UNITED STATES PATENT AND TRADEMARK OFFICE

APPLICATION NO.	FILING DATE	FIRST NAMED INVENTOR	ATTORNEY DOCKET NO.	CONFIRMATION NO.
10/563,354	05/18/2006	Gerhard Schanz	3578	4394
278	7590	10/14/2009		
MICHAEL J. STRIKER 103 EAST NECK ROAD HUNTINGTON, NY 11743			EXAMINER ZALASKY, KATHERINE M	
			ART UNIT 1797	PAPER NUMBER
			NOTIFICATION DATE 10/14/2009	DELIVERY MODE ELECTRONIC

Office Action Summary

DETAILED ACTION

Fig. 3a)

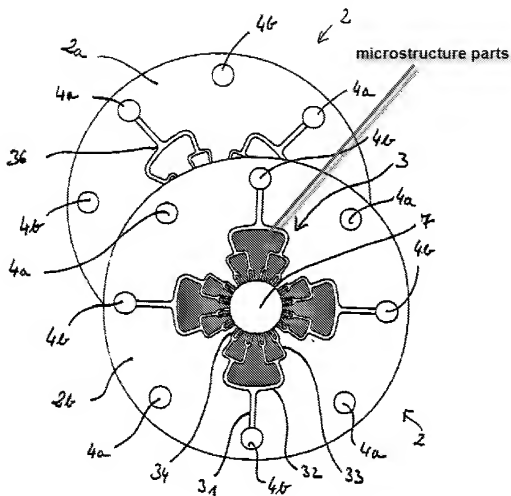
Ehrfeld et al. discloses a static micromixer with at least one component in the form of a disk (Figure 3a, supply element 2, [0051]) and whereby said disk has:

- a single mixing zone, at least one inlet opening disposed in a plane of said disk for introduction of at least one feed stream into a linking channel and with at least one outlet opening disposed in the plane of said disk for outflow of the stream directly into said single mixing zone, said at least one inlet opening being connected with said at least one outlet opening in a communicating manner via said linking channel which is disposed in the plane of said disk (Figure 3a, supply channel 4a, 4b, microchannels 31, 32, 33, 34, outlet at the end of microchannel 34 into opening 7 – becomes mixing zone when all plates are stacked together, [0051])

- said linking channel is divided into two or more part channels by microstructure units immediately before opening into the mixing zone, and each of the part channels has a respective width in a millimeter to sub-millimeter range that is smaller than the width of the mixing zone (Figure 3a, [0051], microchannel 31, 32, 33, 34, opening 7)
- said microstructure units are in contact with said mixing zone (Figure 3a, see annotation below, every shaded microstructure part is in contact with the mixing zone)

In Ehrfeld, the linking channel (microchannel 31) is divided into two or more part channels (microchannels 32, 33, 34) by microstructure units (as labeled above on annotated figure 3a) immediately before opening into the mixing zone (mixing zone formed by opening 7, microchannels 34 empty directly into this mixing zone).

Alternatively, in Ehrfeld the linking channels (microchannels 33) are divided into two or more part channels (microchannels 34) by microstructure units (as labeled above on annotated figure 3a) immediately before opening into the mixing zone (mixing zone formed by opening 7, microchannels 34 empty directly into this mixing zone).
